**AGENDA
TECHNICAL REVIEW COMMITTEE
REGULAR MEETING
AUGUST 25, 2022
10:00 AM
CITY HALL COMMISSION CHAMBERS
204 ASH STREET
FERNANDINA BEACH, FL 32034**

4.1 TRC 2022-0022- Asa Gillette, Gillette & Associates - 3rd/Beech Street 12-Unit Townhome Development - First Round Comments

TRC Case Number: TRC 2022-0022

**1ST ROUND REVIEW COMMENTS:****Planning:**

PREDEVELOPMENT PLAN

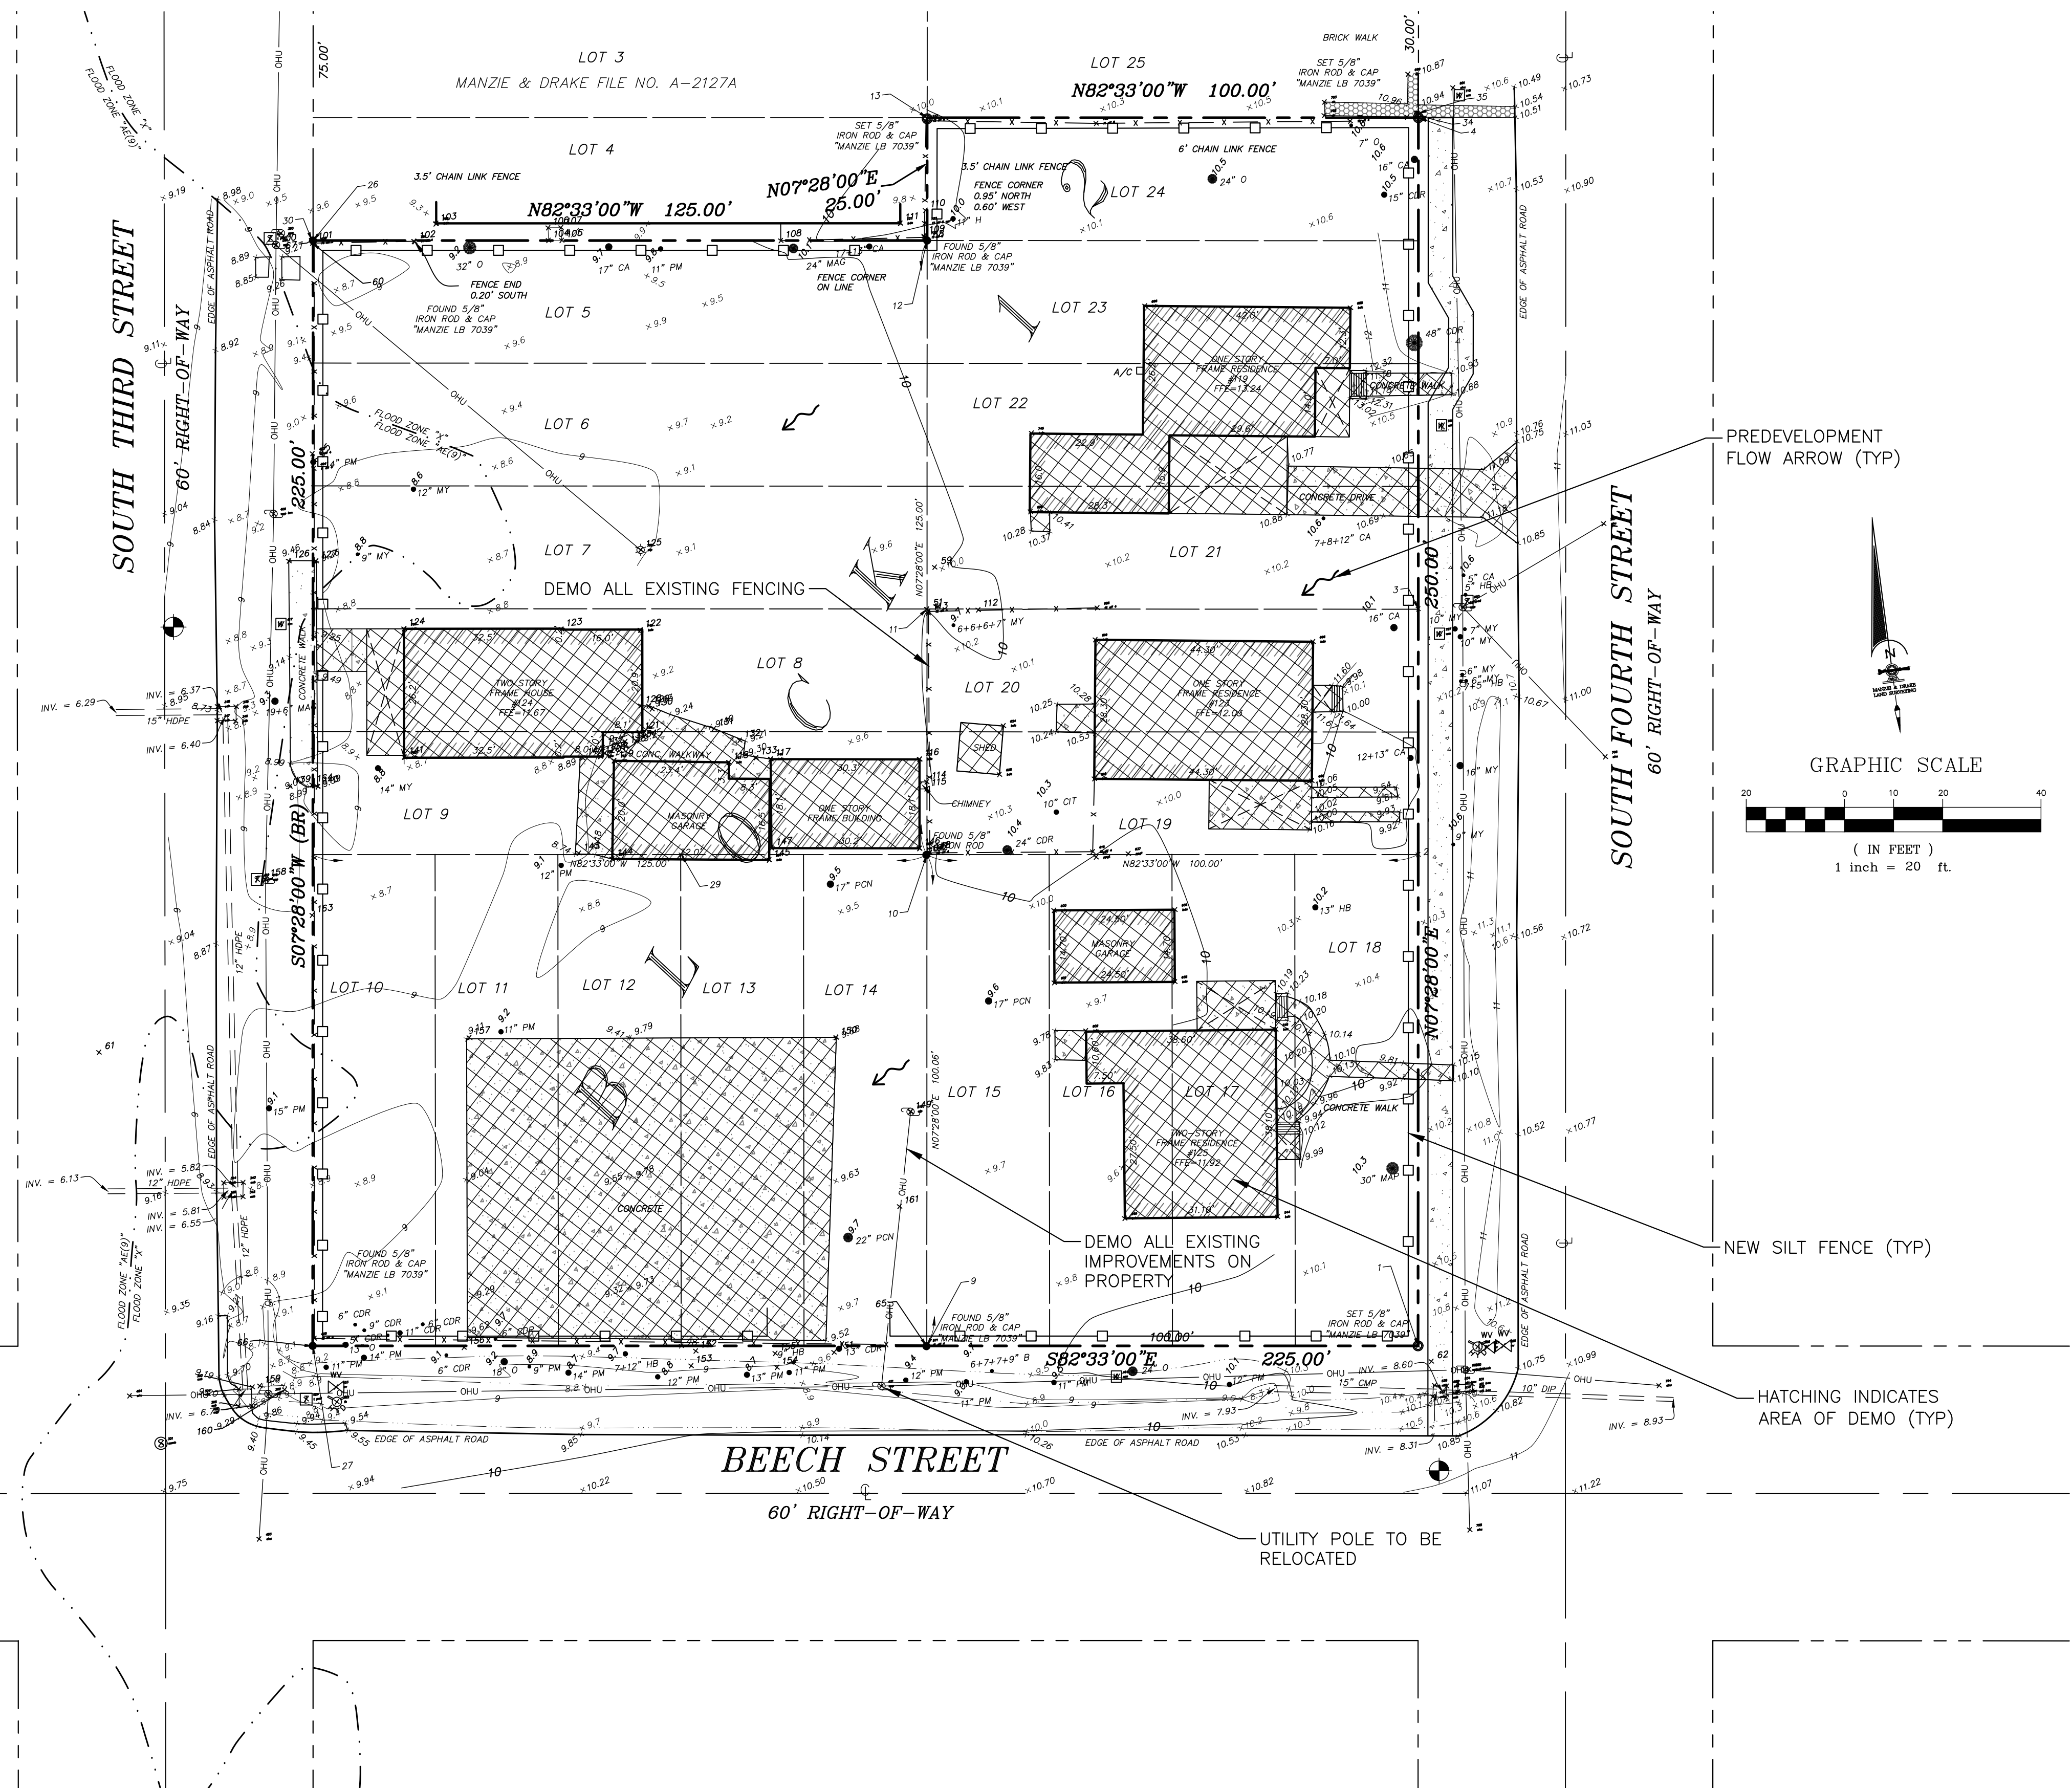
- Please indicate the proposed height or number of stories of the buildings.
- Please show existing hydrants across all applicable pages, such as Geometry, Utility and Landscape Plans. I only found it shown on the predevelopment plan, Sheet PRE-1.
- Can alleyway support the weight of fire department apparatus? If not, vehicle max weight allowed signage will be required, to prevent the drainage system from being damaged.
- For addressing purposes, will the 'front' entrances be facing and have sidewalk/paver access to S 3rd St and S 4th St? It appears to only be landscaping.
